Access Compliance Report

Public Rights-of-Way (Curb Ramps)

Intersection ID: 2739	Main Street: BELL'S_MILL_DR	Cross Street: WINGMONT_DR	Location: NE
ADA ID: 10DDE154C7A3	Ramp Type: PerpDiag	Initial Pass/Fail: Fail	Overall Compliance: No
		Severity Score: 12.5

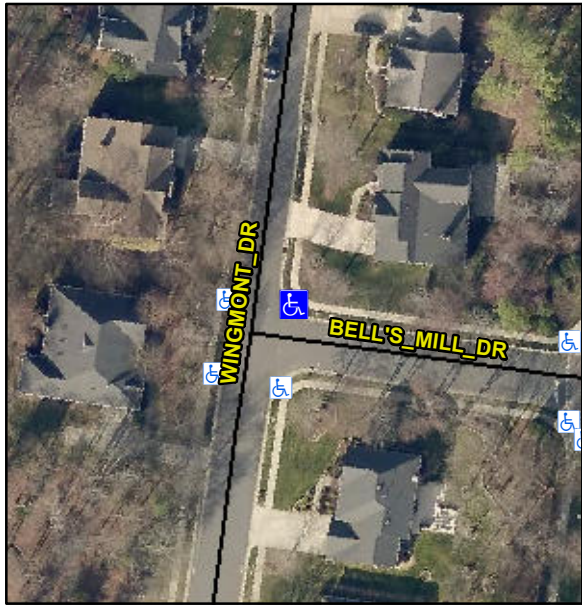
Codes/Mitigation Info/Possible Solution			Field Measurements/Component Compliance					
	Possible Solutions:		Compliance	Description	Data	Compliance	Description	Data
	Remove & Replace Curb Ramp With Two New Directional Ramps or Equivalent.		N/A	Ramp Length (in)	47.5	Yes	Ramp Slope (%)	7.8
			Yes	Ramp Width (in)	48.0	No	Ramp XSlope (%)	5.5
			N/A	Flare Type LT	N/A	N/A	Flare Type RT	N/A
			N/A	Flare Slope LT (%)	N/A	N/A	Flare Slope RT (%)	N/A
			N/A	Flare Traversable LT?	N/A	N/A	Flare Traversable RT?	N/A
			N/A	Landing Length (in)	N/A	N/A	DWS Provided?	N/A
			N/A	Landing Width (in)	N/A	N/A	DWS Contrast?	N/A
			N/A	Landing Slope (%)	N/A	N/A	DWS Length (in)	N/A
			N/A	Landing X Slope (%)	N/A	N/A	DWS Full Width?	N/A
Surveyor Notes:		N/A	N/A	Landing Curb? (Y/N)	N/A	N/A	DWS Offset (in)	N/A
PROW/ADA:		Not Found, R304.5.3	N/A	Shared Landing?	N/A			
			N/A	Gutter Ponding?	N/A	N/A	Gutter Slope (%)	N/A
			N/A	Gutter Lip Ht (in)	N/A	N/A	Gutter X Slope (%)	N/A

N/A	Painted X Walk1?	No	N/A	Painted X Walk2?	No
				X Walk 1 Direction	To W		X Walk 2 Direction	To S
			N/A	X Walk 1 Width (in)	N/A	N/A	X Walk 2 Width (in)	N/A
				X Walk 1 Slope (%)	1.6		X Walk 2 Slope (%)	5.7
				X Walk 1 X Slope (%)	2.2		X Walk 2 X Slope (%)	4.7
			N/A	Ramp inside XWalk1?	N/A	N/A	Ramp inside XWalk2?	N/A
				Road Slope (%)	3.2	N/A	Clear Space?	N/A
				Road X Slope (%)	4.5	N/A	Clear Space to XWalk (in)	N/A
			N/A	Any Obstructions?	N/A	N/A	Storm Grate/Utility Hazard?	N/A
				Obstruction Type			Storm Grate/Utility Type	
					N/A			N/A
						Yes	Surface Condition? (G/P)	Good
Total Cost:		\$ 3200.00						
Street 1 Name		WINGMONT DR						
Stop Condition-Street 2		None						
Street 2 Name		BELL'S MILL DR						
Stop Condition-Street 1		StopSign
